Big Picture for VR, and Interoperability

IEEE P802.3db 100 Gb/s, 200 Gb/s, and 400 Gb/s Short Reach Fiber Task Force

TF Interim Teleconference, July 19, 2021

TBDs for VR

Taps 9, 50m (TDECQ filter=21 GHz)

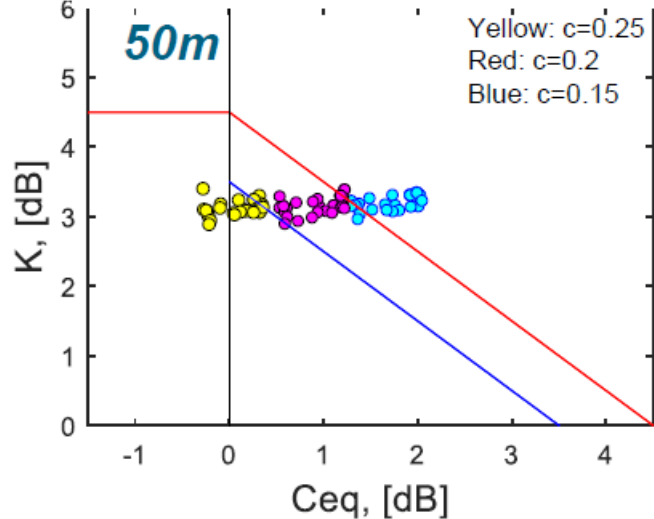
No significant difference in TDECQ between 7 and 9 taps for 50m reach.

— TDECQ 4.5 dB

— TDECQ 3.5 dB

TDECQ versus OM4 link length for 5-tap Rx FFE (blue), 7-tap Rx FFE (cyan), 9-tap Rx FFE (green) and 23-tap Rx FFE (red)
If TDECQ is not measurable at a particular length, then a data point is not shown

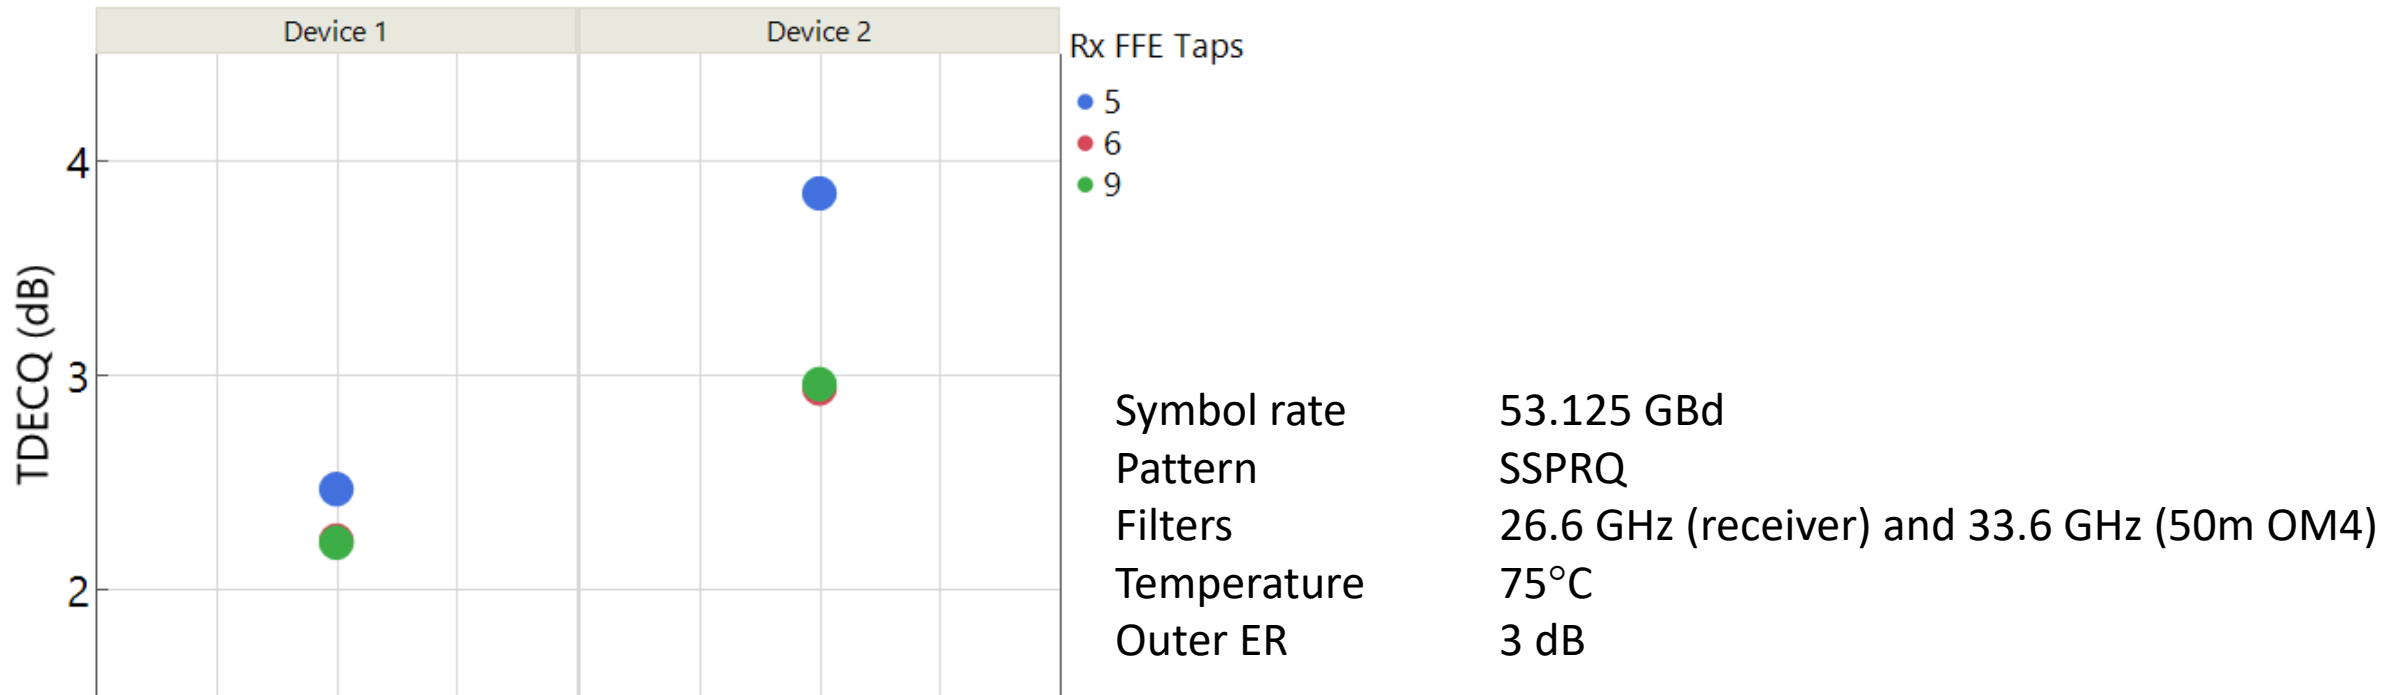
- 6 taps on the reference equalizer appear sufficient for the 50m OM4 reach.
- Module manufacturers need margin on the max TDECQ.
Max TDECQ could be reduced to 4 dB for the 50m reach.
